**Recommendation Report**  
**Detailed Planning Analysis**

**Owner: Lightpoint (170 Lakeshore Road East Port Credit) Inc.**

**170 Lakeshore Road East**

**Building Transition:**

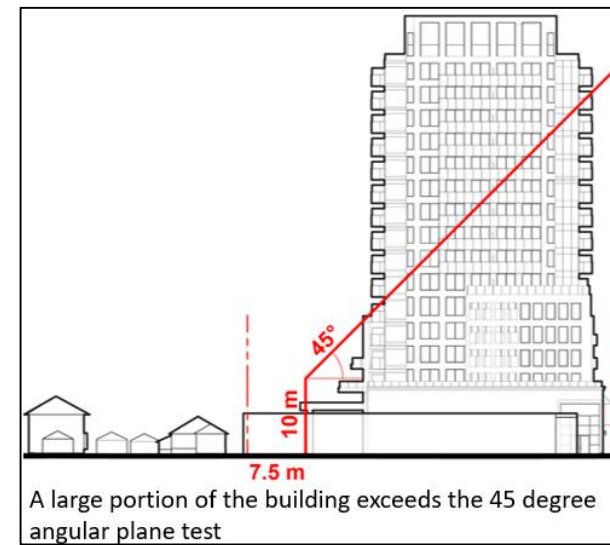
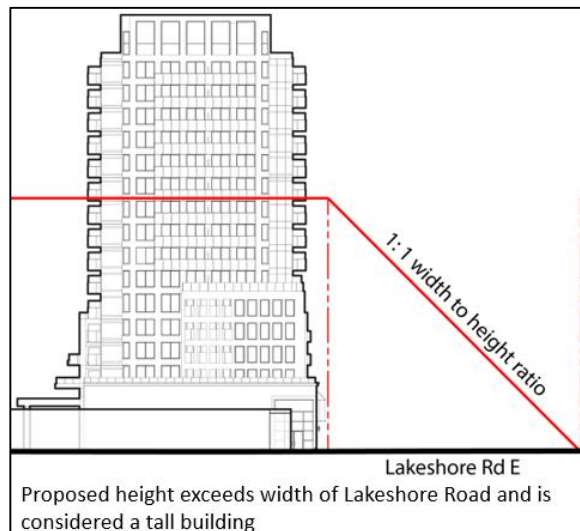
To assess whether a proposed development is providing appropriate transition, the City utilizes a 45 degree angular plane test. Transition can be incorporated into building design through the use of setbacks from the property line and building step backs. A large portion of the proposed building falls outside of the plane and the height should be reduced.

#### Shadow Impacts:

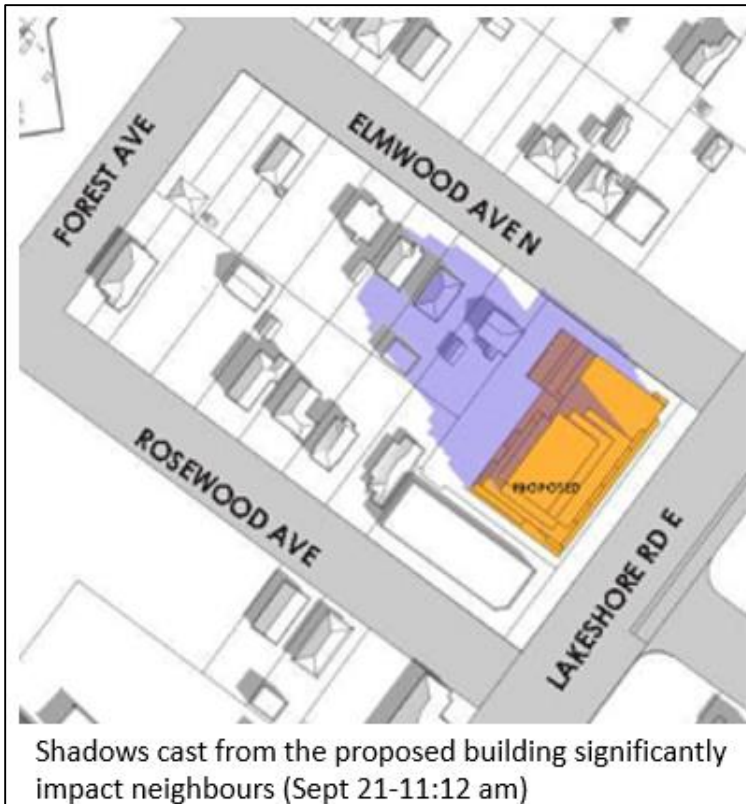
Based on the submitted sun/shadow study the proposal fails required criteria in the City's terms of reference. In particular, the proposed massing significantly impacts the rear yard amenity space of 3 Rosewood Avenue, 10 Elmwood Avenue, and 12 Elmwood Avenue. Shadows cast from the proposed building impact the adjacent rear yard amenity space (i.e. the area between the dwelling and a 7.5 m setback from the rear wall) for more than 2 hours failing criterion 3.1 set out in the City's terms of reference.

Furthermore, the same shadows cast on the Elmwood dwellings fail criterion 3.5, which is intended to ensure adequate sunlight on building faces to ensure the possibility of solar power usage. The building massing and height should be reduced to better mitigate impacts and improve compatibility.

In addition, the sun/shadow study was not prepared in accordance to the City's terms of reference and required information was not provided. There may be additional impacts from the proposed building not identified.
